HISTORIC AND DESIGN REVIEW COMMISSION

HDRC CASE NO: 2021-253
ADDRESS: 297 LOVERA BLVD
LEGAL DESCRIPTION: NCB 9004 BLK 2 LOT 105, 106 & E 20.5 FT OF 107
ZONING: NC,H
CITY COUNCIL DIST.: 1
DISTRICT: Olmos Park Terrace Historic District
APPLICANT: CHERYL PALOMO/INSURANCE ANALYTICS GROUP, INC.
OWNER: CHERYL PALOMO/INSURANCE ANALYTICS GROUP, INC.
TYPE OF WORK: Installation of a rear parking pad, construction of a rear ADA ramp
APPLICATION RECEIVED: May 18, 2021
60-DAY REVIEW: Not applicable due to City Council Emergency Orders
CASE MANAGER: Stephanie Phillips
REQUEST:

The applicant is requesting a Certificate of Appropriateness to:

1. Install a decomposed granite parking pad in the rear yard to accommodate 4 cars.
2. Construct a rear wooden ADA ramp.

297 LOVERA DRIVE / PROPOSED SITE PLAN

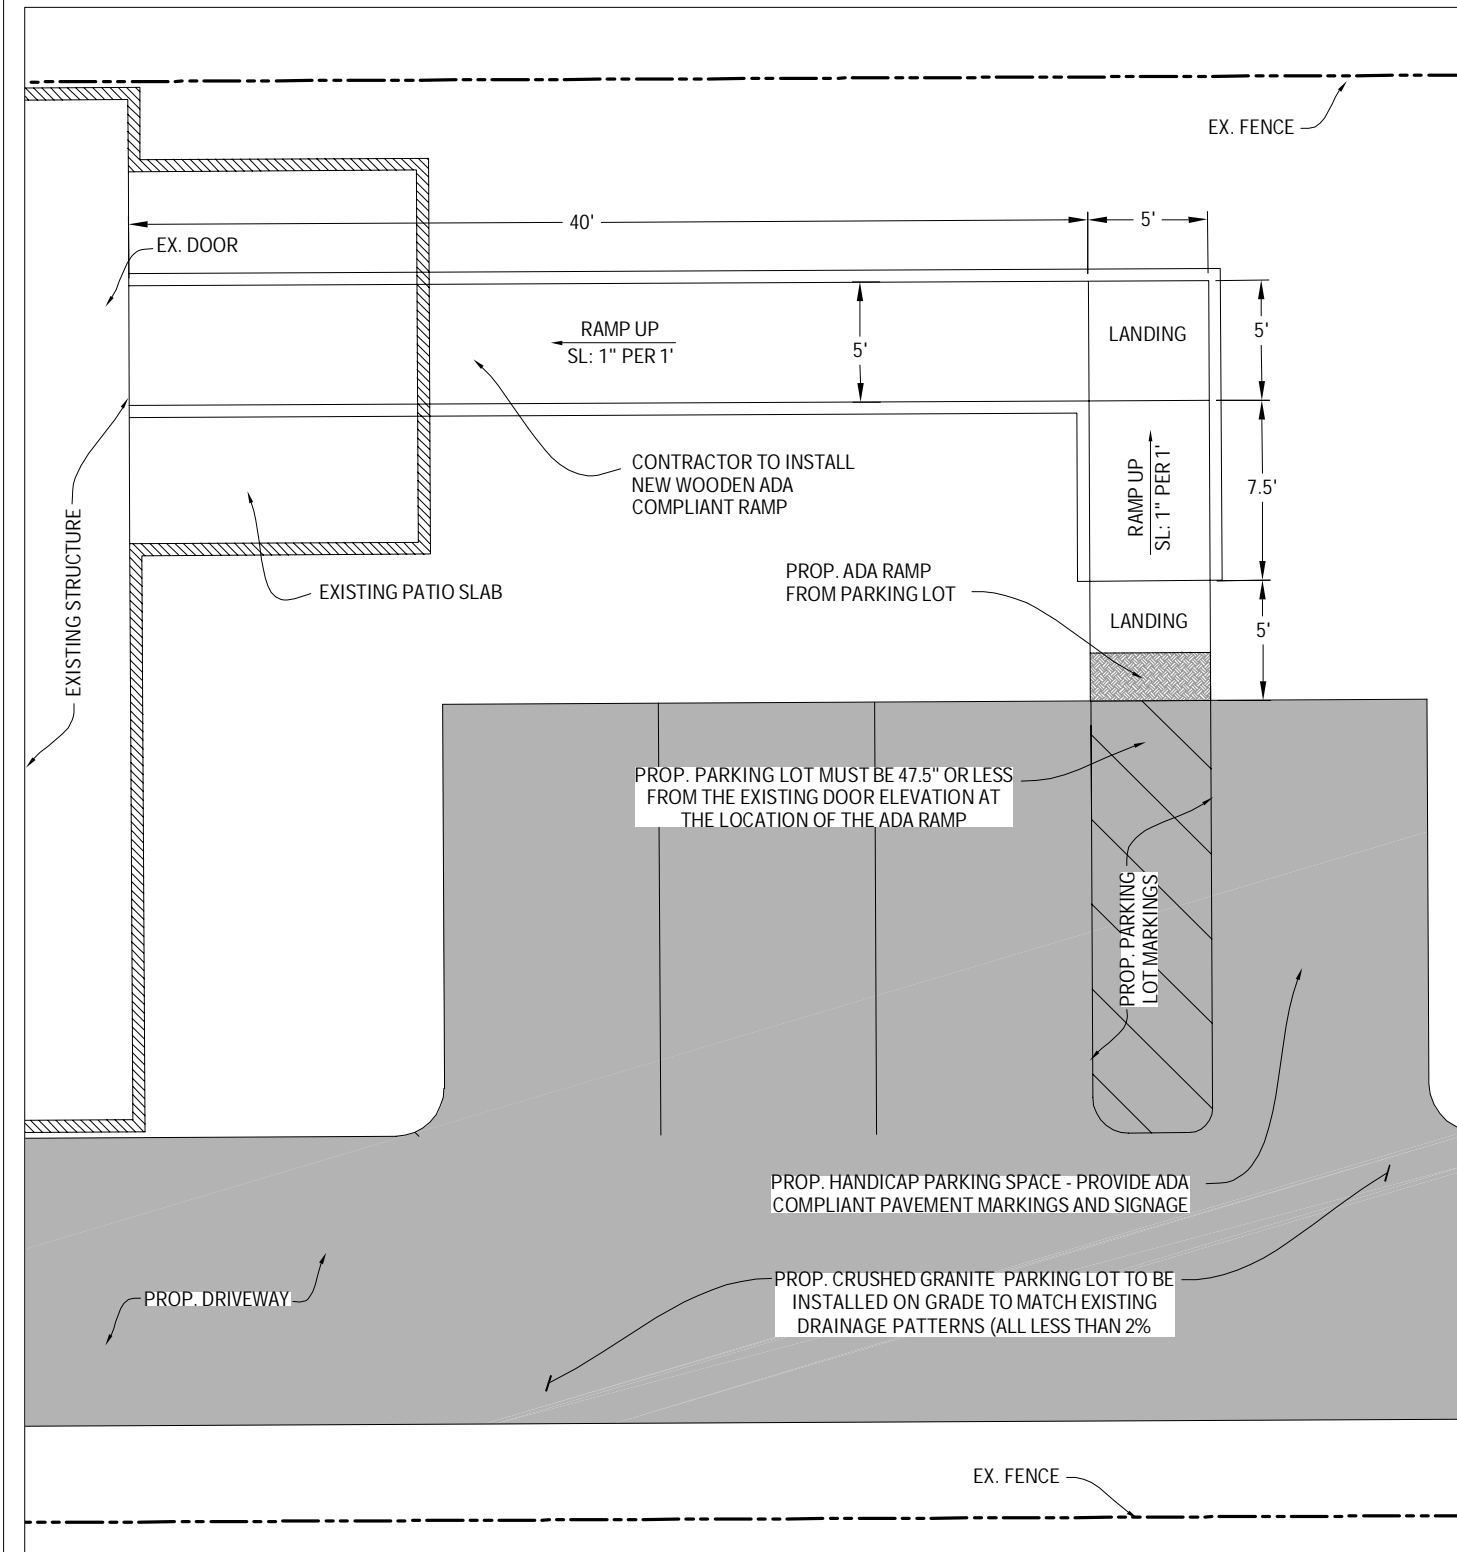
- b. **PARKING AREA** – The applicant has proposed to install a new surface parking pad in the rear of the lot to accommodate parking for 4 cars. The lot will be located fully behind the primary structure and a privacy fence and will be accessed via the existing concrete driveway fronting Lovera Blvd. According to the Guidelines, parking areas on corner lots should be located behind the primary structure and set back as far as possible from the side streets. The parking area will utilize an existing driveway for access and will be decomposed granite, minimizing the added impervious cover on the site. Staff finds the request appropriate based on location, materiality, limited visibility, and the site-specific conditions of the request.

Staff recommends approval of the request items based on findings a through c.

ADA RAMP PLAN VIEW
SCALE: 1"= 8'

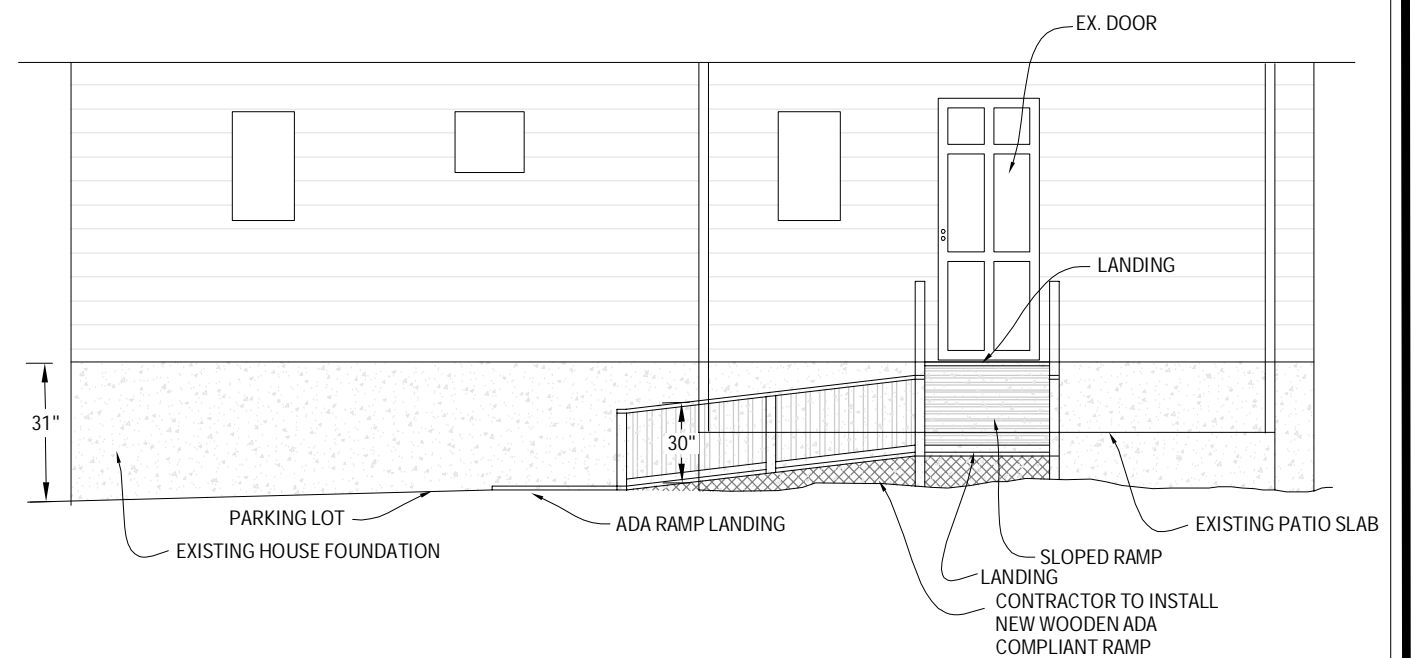
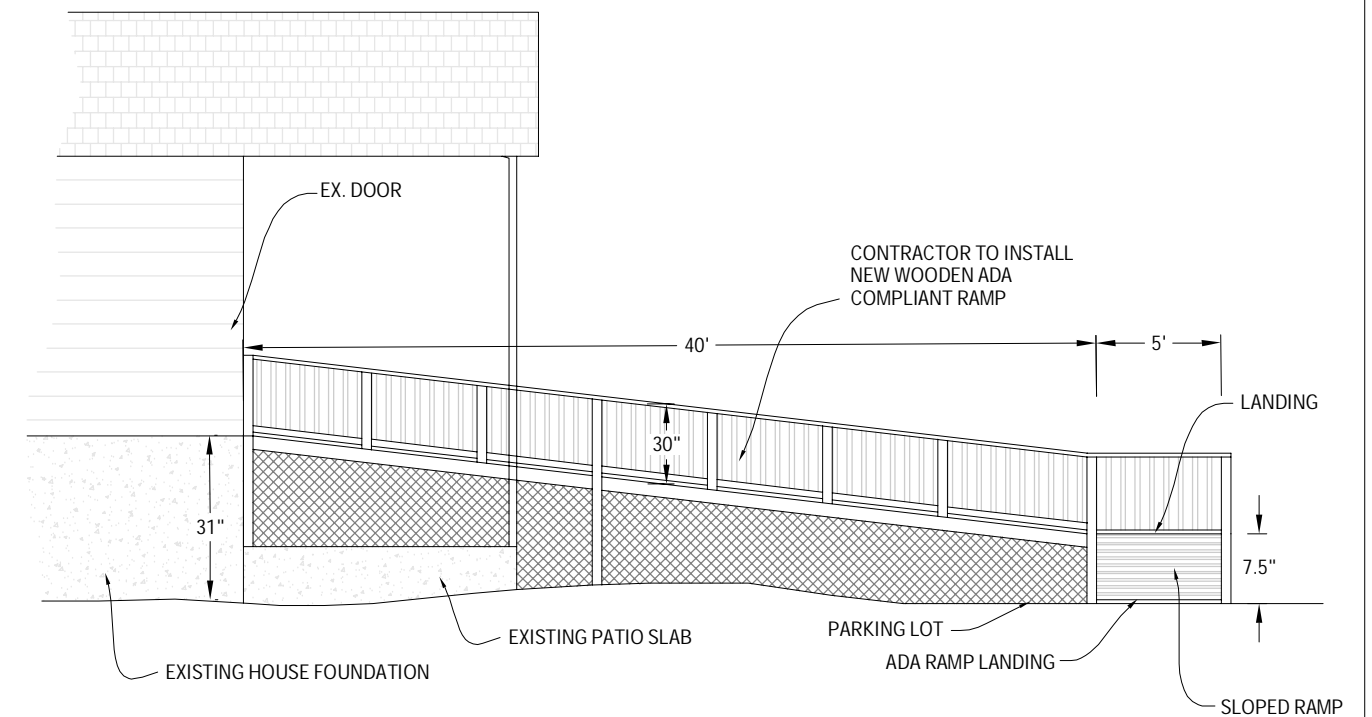
- c. **ADA RAMP** – The applicant has proposed to construct a rear wooden ADA ramp to provide access to the structure from the proposed rear parking area. Staff finds the request eligible for administrative approval.
